Date: May 05, 2004

To: T10 Committee (SCSI)

From: George Penokie (IBM/Tivoli)

Subject: SAM-3: Converting to UML part 1

Figure 4 — Logical unit class diagram

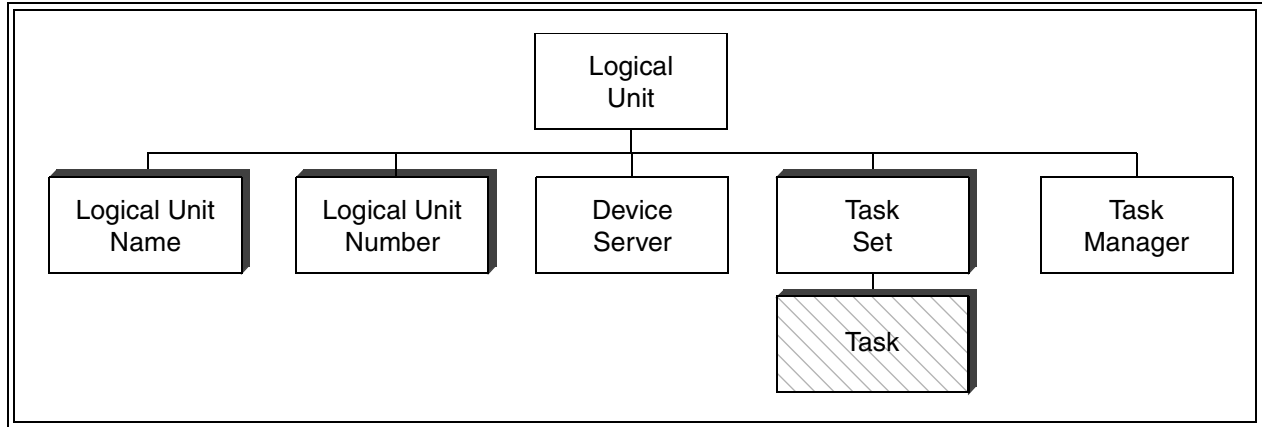
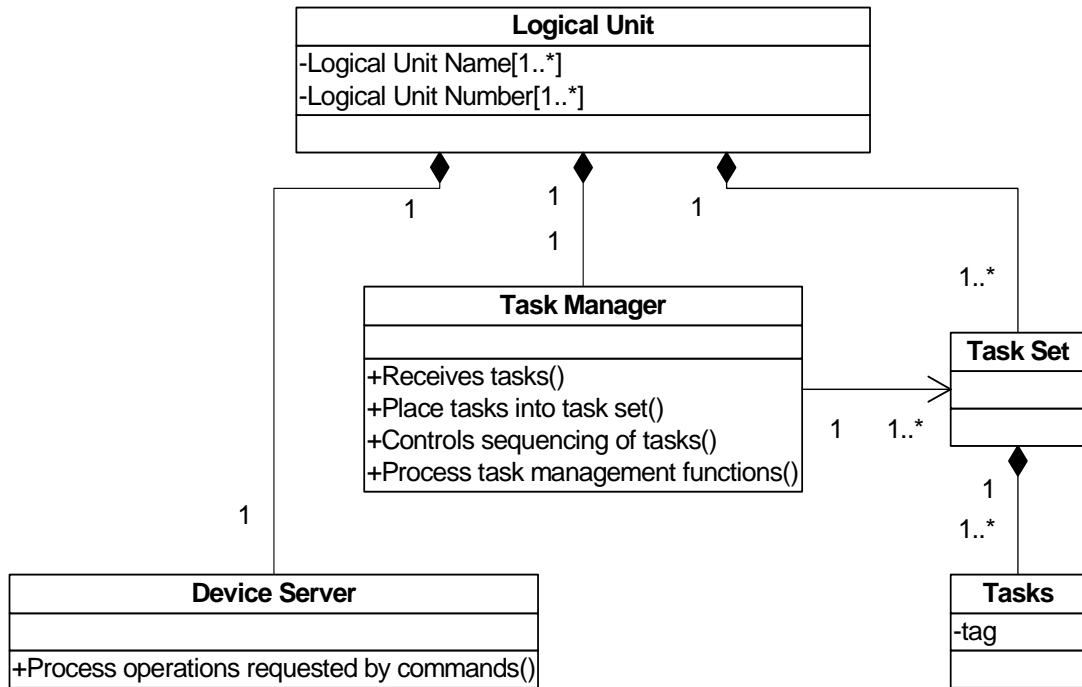
For an example of what figures in SAM-3 would look like a converted logical unit model (see figure 3) as currently shown in SAM-3 would look like what is shown in figure 4.
